# Change Bulletin

No: CB037

## Description: Change Seal installation for EMI 400 Gearbox Assembly

Figure 1: Seal Placement Before

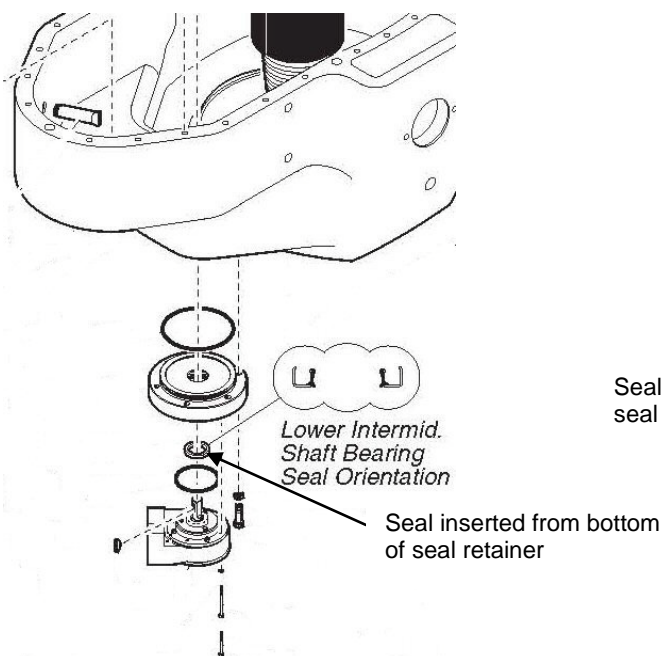
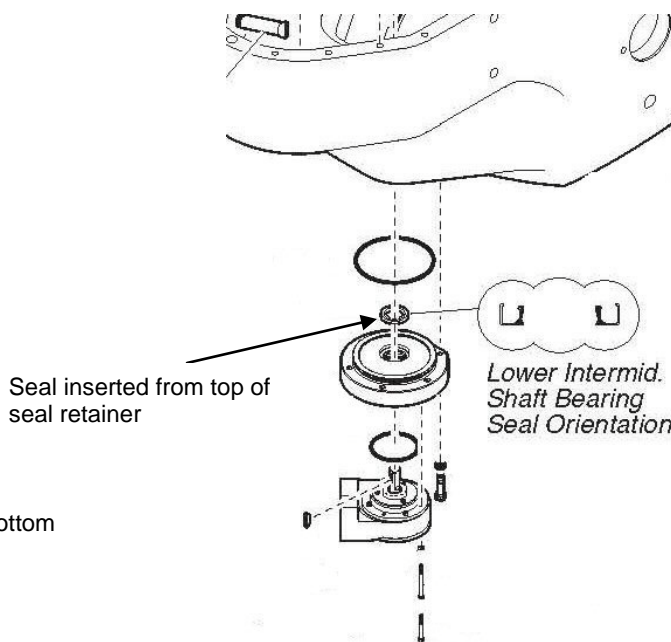
During gearbox assembly, it was noticed that tolerance stackup could result in the input shaft chamfer sitting on the edge of the seal which could cause leaks.

TESCO changed the seal retainer so that the seal is inserted from the top rather than the bottom (see Figure 1 and 2 below).
